Access Compliance Report

Public Rights-of-Way

(Curb Ramps)

Intersection ID: 30689	Main Street: ANSLEY_WALK_LN	Cross Street: CHATSWORTH_CT	Location: NW
ADA ID: 5731B5A05D47	Ramp Type: BlendTrans1	Initial Pass/Fail: Fail	Overall Compliance: No
		Severity Score: 60

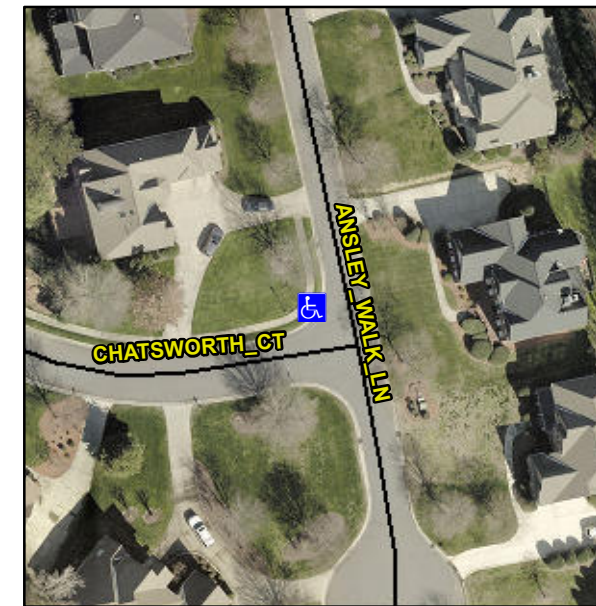
GTR GAP 1.5, LNDG LIP 1.0

R304.5.1, R304.5.3

Remove & Replace Curb Ramp With Two New Directional Ramps or Equivalent.
